# 10 Mb/s Single Twisted Pair Ethernet 10BASE-T1L PHY Control State Diagram Version 2 (Comment #584)

Steffen Graber, Pepperl+Fuchs

# 10BASE-T1L PHY Control State Diagram

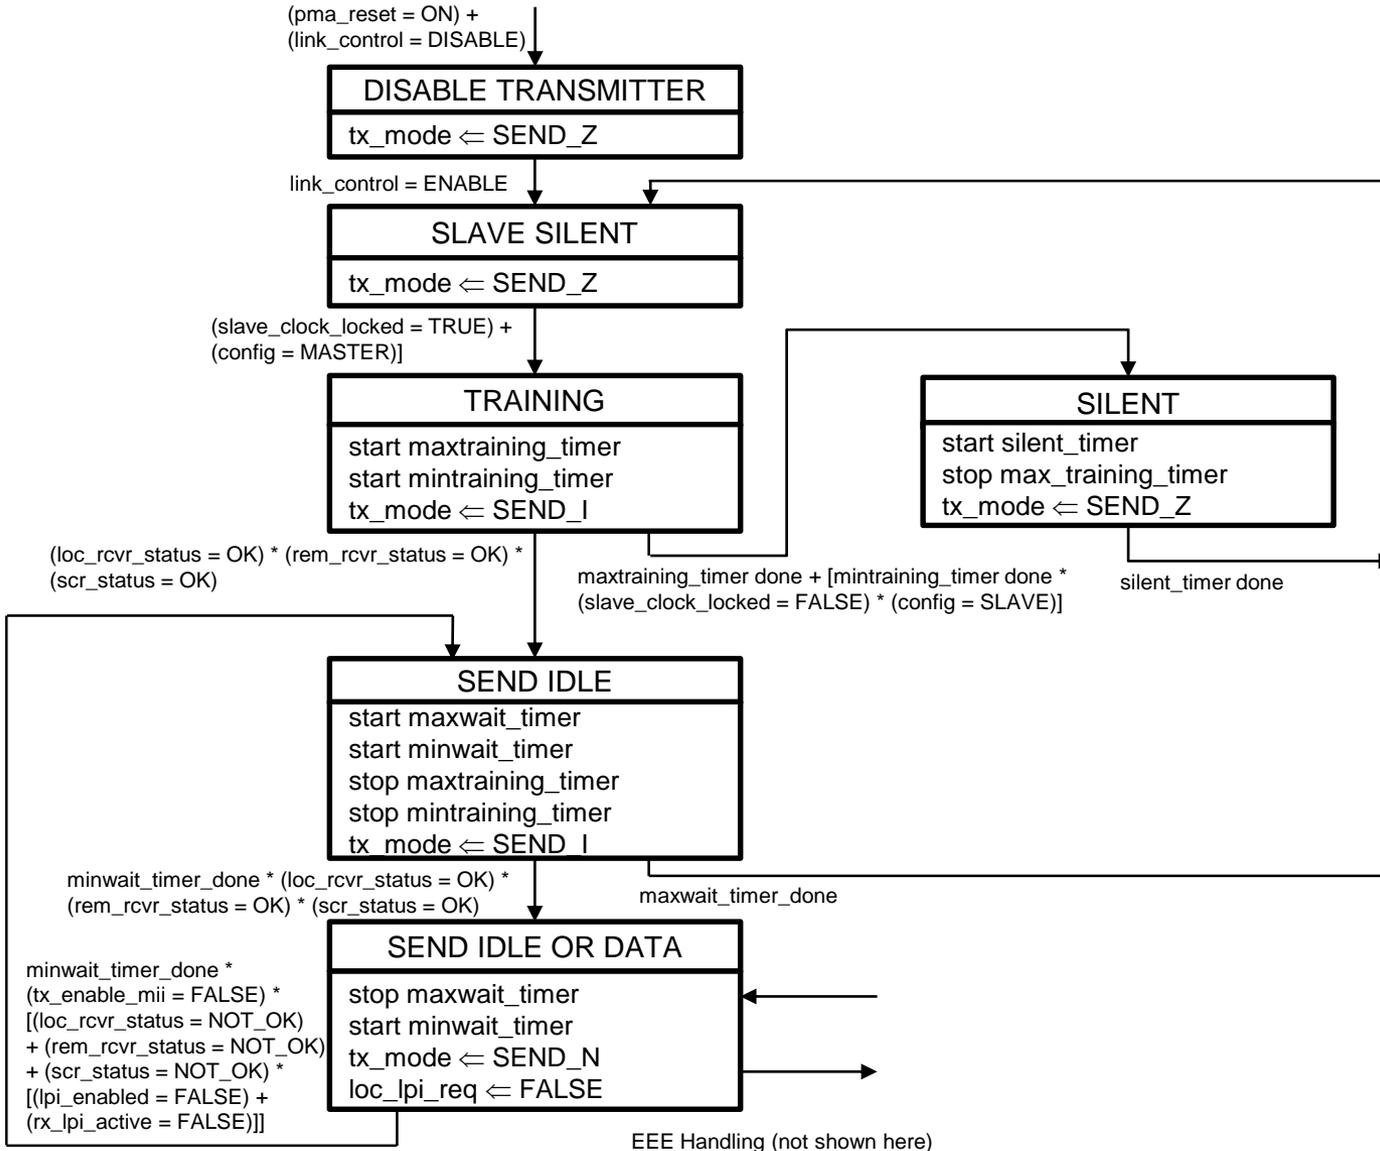
- Depending on the implementation the PHY Control state machine in D2.0, can run into synchronization issues, if FORCE mode is active. See presentation:

- Main reason for these issues is that both, Master and Slave PHY provide a “training\_timer”, which limits the maximum time, a PHY may stay in training and if both timers are not synchronized, then it can happen, that for one PHY only a part of the training time remains, so that this PHY cannot finalize the training and therefore has to start training again.
- This condition may, depending on the implementation, persist for a longer time.
- To solve this issue, some changes in the PHY Control state machine are suggested.
- **The race condition between the training timers in the master and the slave PHY is solved by not only keeping the slave PHY in SILENT state, until the slave clock is acquired, but also the master PHY, thus allowing the slave PHY to synchronize on the master PHY training.**

Rename „training\_timer“ to „maxtraining\_timer“.

Add the following timers to the timer section:

**mintraining\_timer:** A timer used to set the minimum time a slave PHY stays in training mode before going to SILENT state in case a loss of clock lock is detected. The timer shall expire  $100\text{ ms} \pm 1\text{ ms}$  after being started.

**silent\_timer:** A timer used to set the time a PHY stays in SILENT state. The timer shall expire  $100\text{ ms} \pm 1\text{ ms}$  after being started.

Add the following variable to the variables section:

**slave\_clock\_locked:** This variable is set TRUE, if the clock recovery circuit on the slave PHY detects a stable clock, locked on the master PHY clock. Implementations may benefit from checking `scr_status` for deciding, if the slave clock is locked. If there is no signal received from the master PHY or the slave clock is unstable, this variable has to be set back to FALSE.  
Values: TRUE or FALSE
